BULLETIN

Piper Aircraft Corporation
Vero Beach, Florida, U.S.A.

(Service Bulletin No. 924 supersedes and voids Service Letter No. 392 dated January 17, 1963)

SUBJECT: Shimmy Dampener Replacement

SKETCH "A"

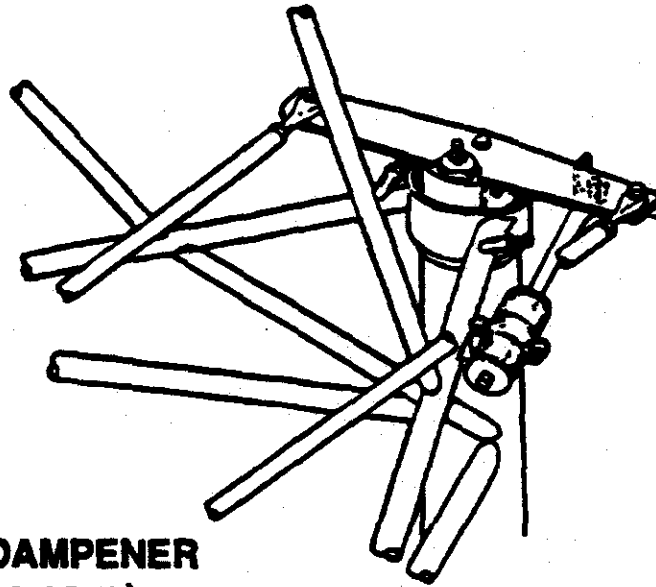
- 1. Remove cowling as necessary to gain access to nose wheel shimmy dampener. Refer to applicable Owners Manual or Parts Catalog.
2. Shimmy Dampeners with Piper Part Number 13086-00, as identified on Sketch A (attached), should be removed, discarded and replaced by Piper Part Number 21701-06.

This Service Bulletin recommends the shimmy dampener currently installed in the affected model aircraft be replaced by a new Shimmy Dampener, Piper Part Number 21701-06, and provides instructions for continuing maintenance at regular intervals.

SKETCH "B"

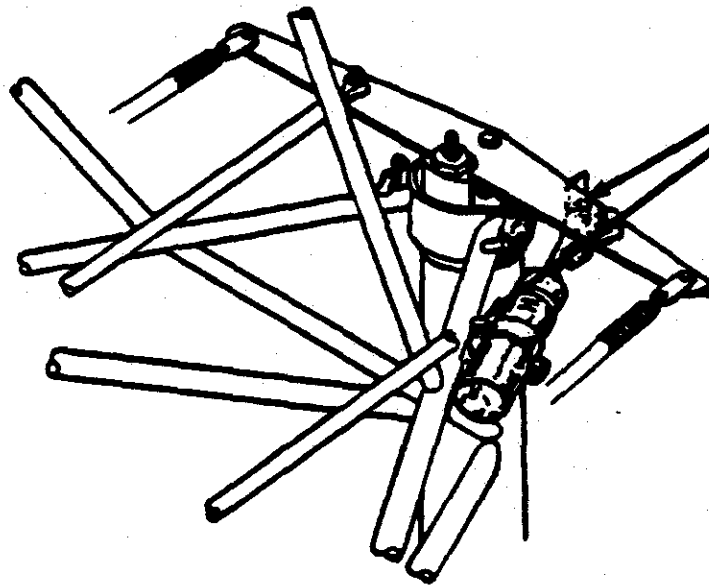
3. If the shimmy dampeners with Piper Part Numbers 21701-02 and 21701-04, Sketch B (attached), are inspected and determined to be serviceable and airworthy and the instructions below are complied with, those shimmy dampeners may be returned to service.

4. Determine that nose wheel travel is 20 degrees left and right of center.
5. Determine that the shimmy dampener rotates freely on the axis of its attachment bolt throughout its full travel, especially as it approaches the limits of nose wheel travel.

6. Determine that the attachment of the shimmy dampener rod end to the nose wheel steering arm is free to accept angular travel in either direction.
7. Should any stiffness, restrictions, or other maladies be noticed, correct by replacing parts and adjusting as necessary until proper fit and function is obtained.

8. A regular maintenance routine of inspection, cleaning, and lubrication should be performed at each one hundred (100) hours of operation or at any inspection event. Lubricate shimmy dampener rod end and pivot point using general purpose low temperature oil (MIL-L-7870 or equivalent). Wipe shimmy dampener shaft using a clean cloth saturated with MIL-H-5606 hydraulic fluid.
